# HISTORIC AND DESIGN REVIEW COMMISSION

**HDRC CASE NO:** 2021-283  
**ADDRESS:** 414 MISSION ST  
**LEGAL DESCRIPTION:** NCB 945 BLK LOT 31  
**ZONING:** RM-4,H  
**CITY COUNCIL DIST.:** 1  
**DISTRICT:** King William Historic District  
**APPLICANT:** Nathan Manfred/French & Michigan  
**OWNER:** CARRANZA JOSE A & MARGARET  
**TYPE OF WORK:** Exterior and porch modifications  
**APPLICATION RECEIVED:** May 27, 2021  
**60-DAY REVIEW:** Not applicable due to City Council Emergency Orders  
**CASE MANAGER:** Stephanie Phillips

## REQUEST:

The applicant is requesting a Certificate of Appropriateness for approval to perform front porch modifications, to include extending the first floor decking to align with the front façade, adding simple wooden railings and newel posts, and constructing new front stairs.

**1 WEST ELEVATION (FRONT)**  
SCALE: 1/4" = 1'-0"

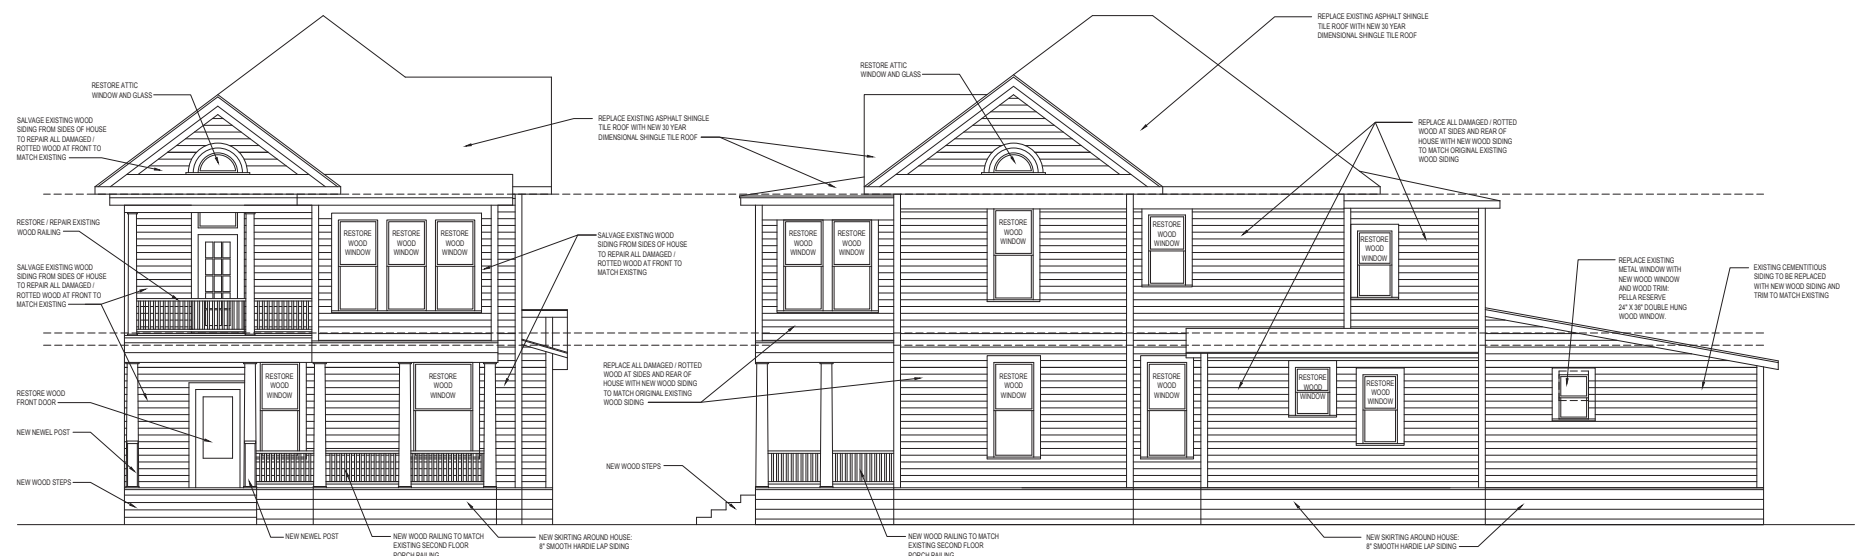
- b. PORCH MODIFICATIONS – The applicant has proposed to extend the front porch decking on the first story to meet the existing front plane of the historic front porch. The original porch footprint is largely intact per Sanborn Maps. The applicant has not proposed to modify the current location of the second floor porch. The existing columns will remain and new newel posts will be added, in addition to a new wood railing on the northern elevation. According to the Guidelines, the replacement or addition of new porch elements, such as stairs and railings, should be designed to be simple so as to not distract from the historic character of the building. Do not add new elements and details that create a false historic appearance. As noted, the applicant is retaining the original elements of the porch and extending the porch decking to meet the existing frontmost façade plane. The simple newel posts will not conceal the original columns and will distinguish the extension as a later element. The new stairs will feature a simple tread and riser design that is similar to the existing stairs, which are compatible but not original to the structure. As designed, the proposal is fully reversible and will not result in the loss or obfuscation of historic elements. Staff finds the proposal appropriate based on these design- and site-specific considerations.

The owner is requesting to add to the existing wood front porch so that the North corner is extended out to be flush with the front of the existing porch. New wood steps would be built that would go out to a new concrete landing and front concrete walk. New wood railings matching the second floor porch would be constructed and newel posts wood be installed on the front porch to terminate the railings. The same proposed skirting would enclose the new portion of the extended front porch.

Staff recommends approval based on findings a and b.
